# Work Order ID 83645

Item Name: Replacement Skidtube

DRAWING NO. D2580	TITLE 205 SKIDTUBE ASSEMBLY	REV. E	DART AEROSPACE LTD ENGINEERING ORDER		D.E.O. NO. D2580-E-1	SHEET NO. SHEET 1 OF 1	SCALE NTS
DRAWN <i>UP</i>	CHECKED <i>ASS</i>	MFG. APPR. <i>ER</i>	APPROVED <i>[Signature]</i>		DE APPR. <i>[Signature]</i>		
DATE 11.12.13	DATE 11.12.13	DATE 11.12.13	DATE 11.12.13		DATE 11.12.13

CHANGE ALL C'BORED WELDED CROSSBOLT SPACERS TO SWAGED SPACERS

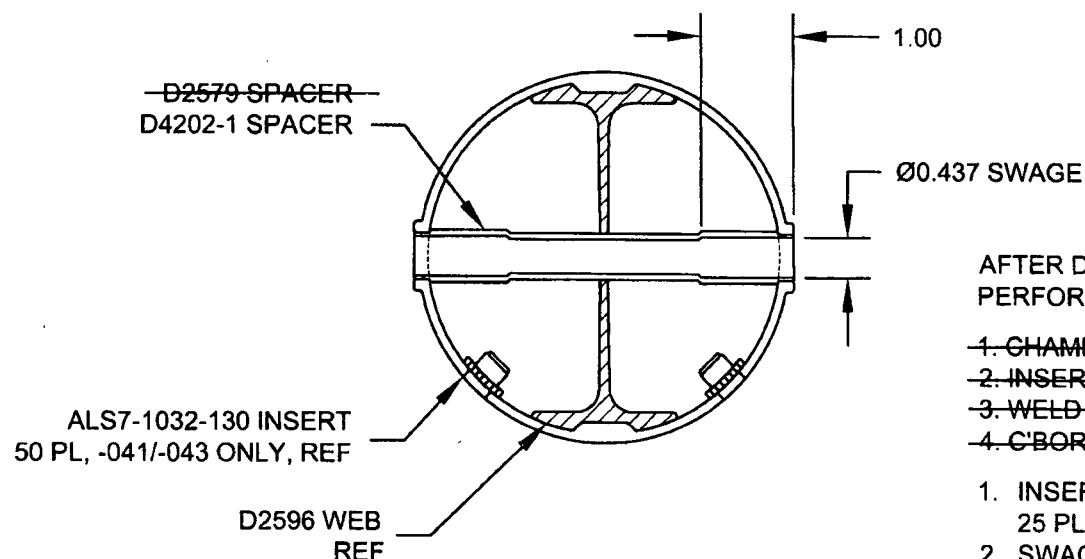
QTY	QTY	QTY	PART NUMBER	DESCRIPTION
-041	-045	-047		
20	24	25	D2579	CROSS BOLT SPACER

4		* D2579	CROSS BOLT SPACER
20	20	25	D4202-1	SPACER

SECTION B-B, SECTION F-F, & SECTION I-I ARE AMENDED AS FOLLOWS  
FOR ALL HOLES THAT WERE ORIGINALLY C'BORED:

WELD 4X D2579 SPACERS PER DWG  
IN LOCATIONS MARKED "NO C'BORE".  
REF SHEET 4 OF DWG.
